**SUBJECT: THREE MILE ISLAND NUCLEAR STATION UNIT 1 AND UNIT 2  
OPERATING LICENSE NO. DPR-50 AND POSSESSION ONLY LICENSE NO. DPR 73  
DOCKET NOS. 50-289 AND 50-320  
SUPPLEMENT TO COMBINED 2008 ANNUAL RADIOACTIVE EFFLUENT  
RELEASE REPORT**

**ODCM change for  
TMI Offsite Dose Calculation Manual, Revision 1  
CY-TM-170-300**

Document Number: <u>CY-TM-170-300</u>		Revision: <u>01</u>	
Title: <u>Onsite Dose Calculation Manual (ODCM)</u>			
<input type="checkbox"/> New	<input type="checkbox"/> Cancel Document	<input type="checkbox"/> Cancel Revision	<input checked="" type="checkbox"/> Revision
EC#: _____		PCR#: <u>PL-26024</u>	PPIS#: _____
<input type="checkbox"/> Editorial		ER#: _____	AR#: _____
<input type="checkbox"/> Batch		#: _____	
<input type="checkbox"/> Supersede corporate document(s) List: _____			
Revision Summary: <u>Update Figure 3.1, correct section 2.2.1.1, clarify note in Table 3.1-2, Part I</u>			
Impact on Operating and Design Margins: <input checked="" type="checkbox"/> N/A			
CONFIRM that <u>no</u> commitments (i.e., those steps annotated with CM-X) have been changed or deleted unless evaluated via completion of LS-AA-110 commitment change/deletion form and INIT

FIGURE 3.1  
TMI-1 Liquid Radwaste

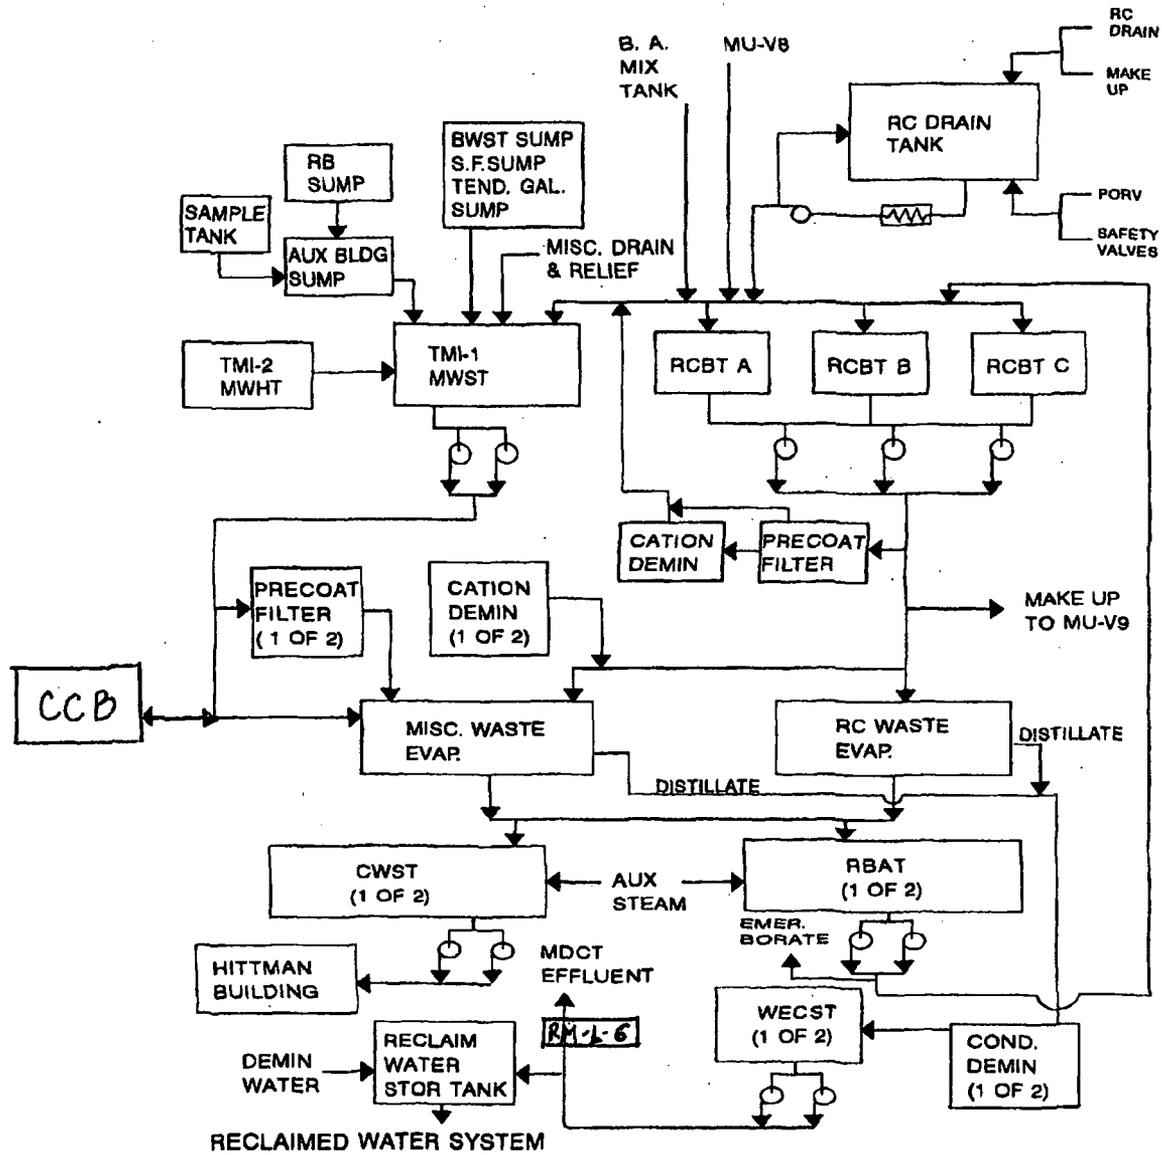
Figure 3.1 is being revised to include pathway to the Chemical Cleaning Building (CCB) and RM-L-6 monitor for liquid radwaste processing. In section 2.2.1.1, DAC is being changed back to MPC. In Table 3.1-2, the note regarding RM-A-7 operability is being clarified. Equation 4.2 is being updated to include Sr-90 for particulate monitor setpoints.

During a walkdown with the NRC during an inspection, it was identified the path to the CCB for the radwaste system and RM-L-6 were not reflected on Figure 3.1. (IR 794671) The reference to MPC in section 2.2.1.1 needs to remain to be consistent with the ICRP 2 reference. (IR 794799) The note clarification in Table 3.1-2 is being made to make it consistent to Table 2.1-2. (IR 757133) The concentration definition for equation 4-2 in section 4.2, needs to be updated to reference I-131 for radioiodine monitors and Sr-90 for particulate monitors. (IR 795519)

Updating Figure 3.1 will have the figure reflect the current configuration in the plant and on plant drawings. Changing the reference back to MPC will maintain consistency between the references in the basis. Clarifying the note in Table 3.1-2 and making it consistent with Table 2.1-2 will improve human performance. Particulate monitor setpoints are currently set using Sr-90 so there is no impact to the plant.
